Date: 2012-11-23

Engineering Change Request – Class I

New BPMs nearby BGI in IP 4

Figure 1: Photographs of proposed locations of BPMs: cells C5L4 and C5R4, between BGIs and D3 magnet, face to BSRT. (Courtesy of Thibaut Lefevre.)

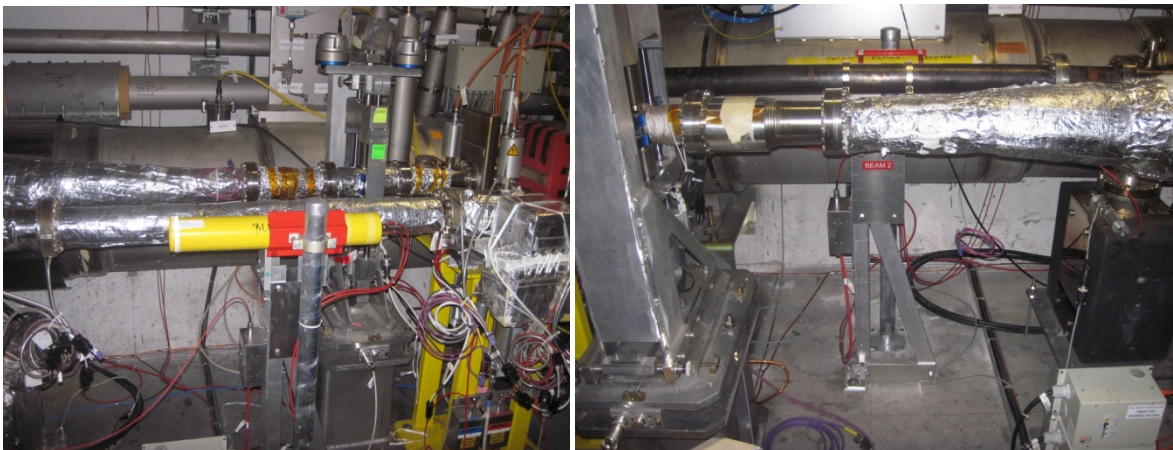
Currently there are no BPMs installed in the vicinity of BGI. Installation of two of such devices will allow more precise orbit measurement inside BGI as well as better determination of the optics function. Precision of orbit measurement is important for beam-based calibration of BGI.

The present situation in the proposed locations of the two new BPMs in cells C5L4 (for beam 1) and C5R4 (for beam 2) are shown on photographs in Figure 1 and on drawings in Figure 2. The vacuum chambers currently installed in these places (VCDEC of 1235 mm and VCDDS of 200 mm) should be replaced with a shorter chambers (VCDFR and VMAAA are proposed), a BPMWI (an enlarged button BPM with an aperture of 80 mm) and its associated bellows.

Figure 3: The proposed modification of the vacuum sectors in C5L4 (beam 1, upper drawing) and C5R4 (beam 2, bottom drawing). (Courtesy of JP Corso).

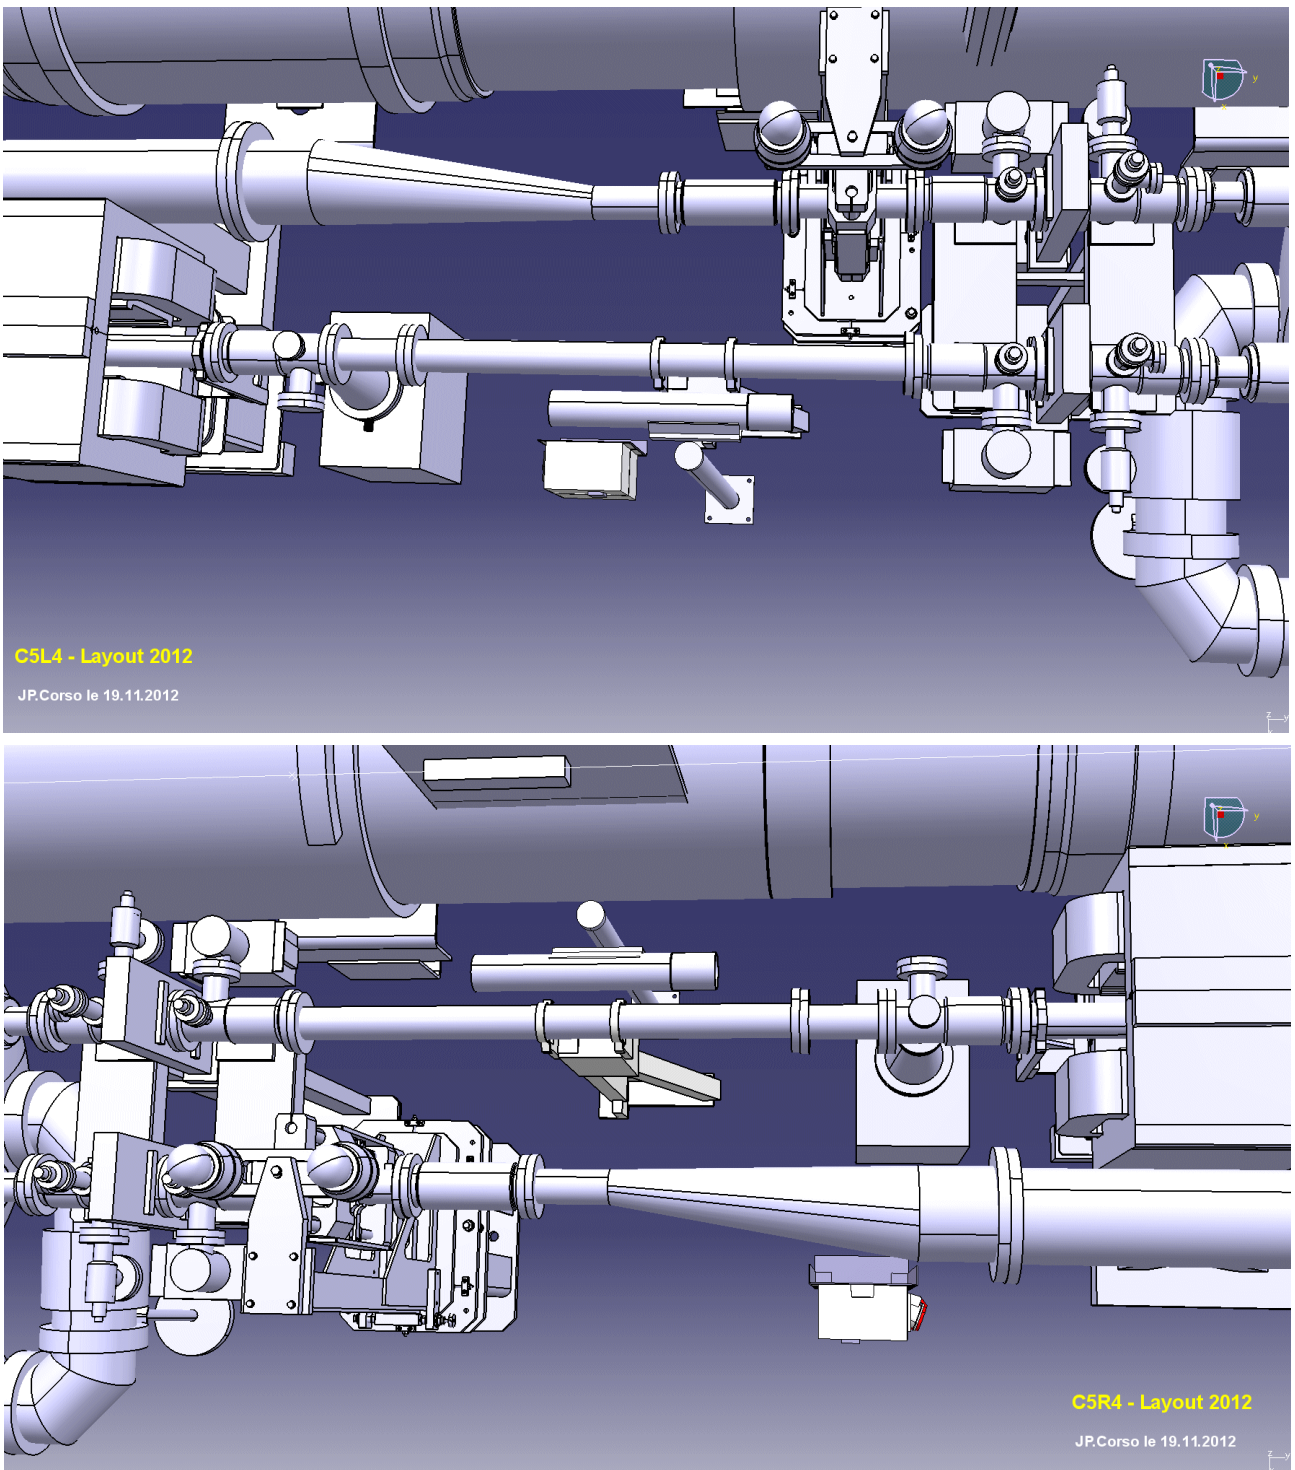
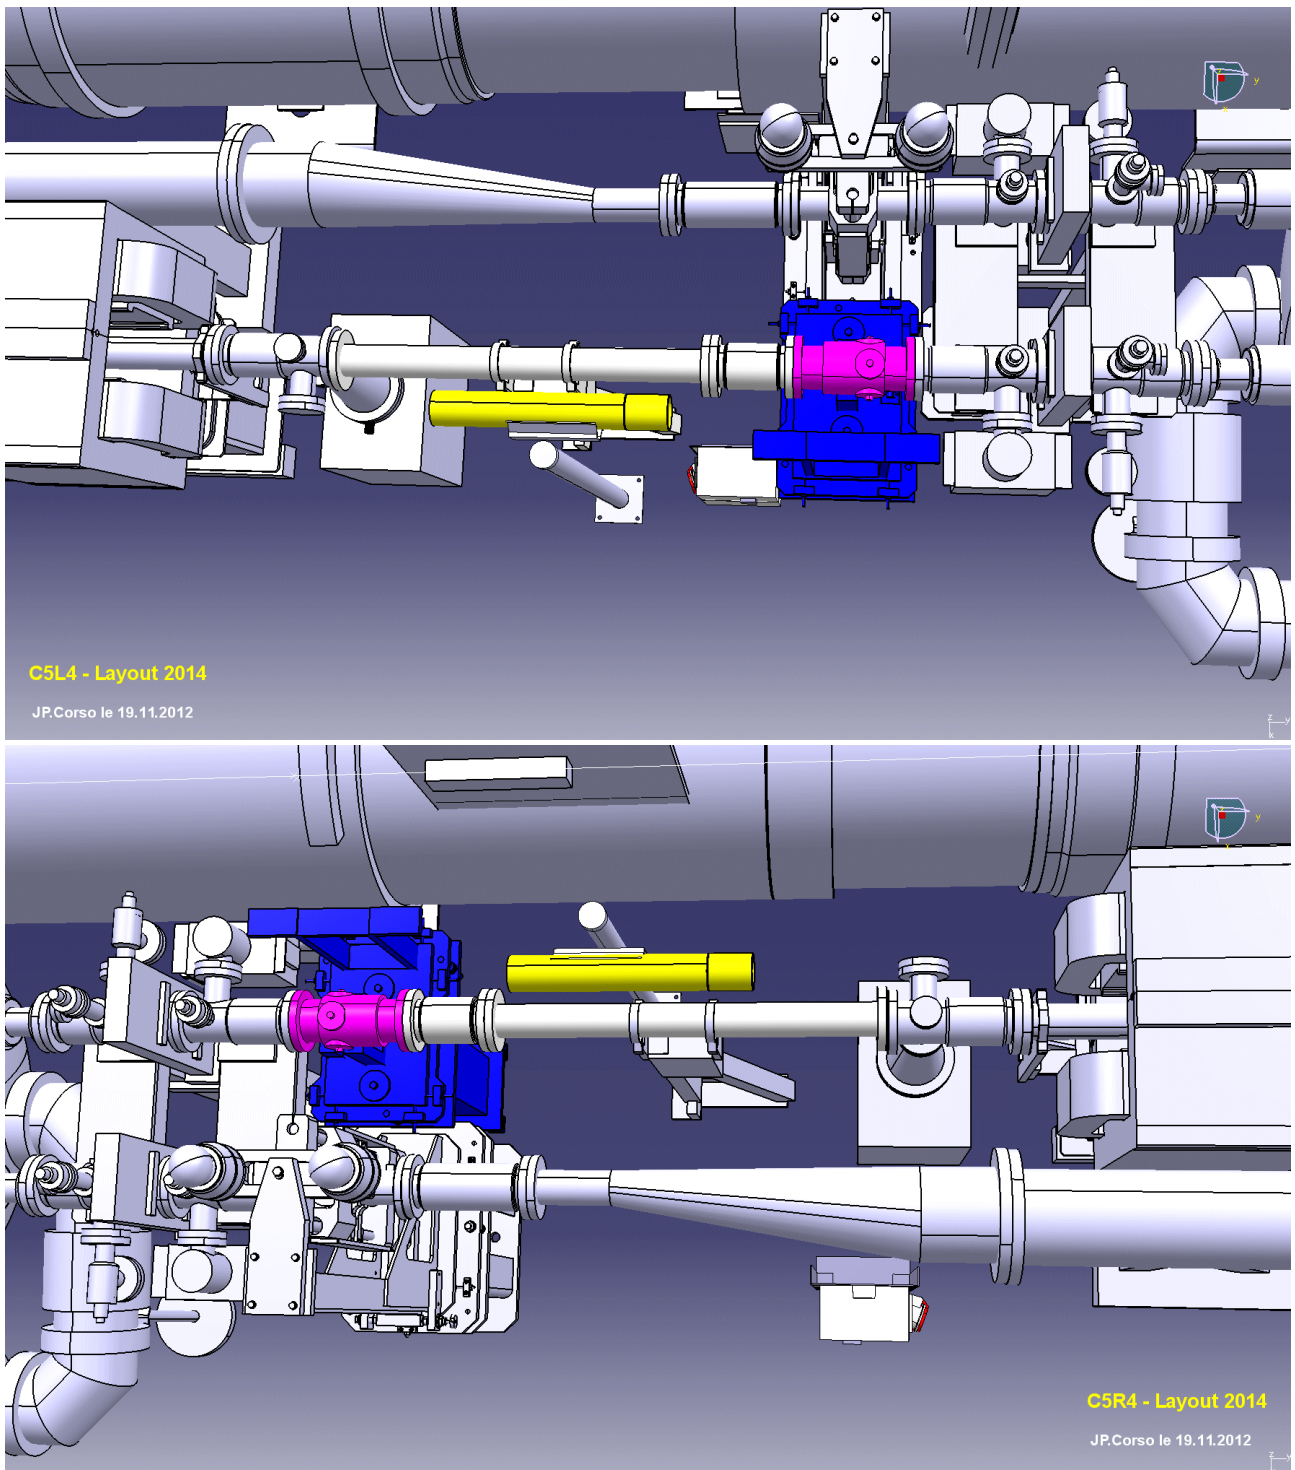
Given the not standard inter-axis distance, a support for a single BPM could be a type LHC BPMHW0020, with the upper plate modified to adapt for this BPM body.

The BLM ionization chambers are currently installed very close to the foreseen BPM location. As agreed with the BL section they will be moved upstream towards the BGI.

The proposed new layouts of the vacuum sectors after BPM integration are shown on drawings in Figure 3. The names and lengths of the present and proposed vacuum elements are detailed in Tables 1 and 2.
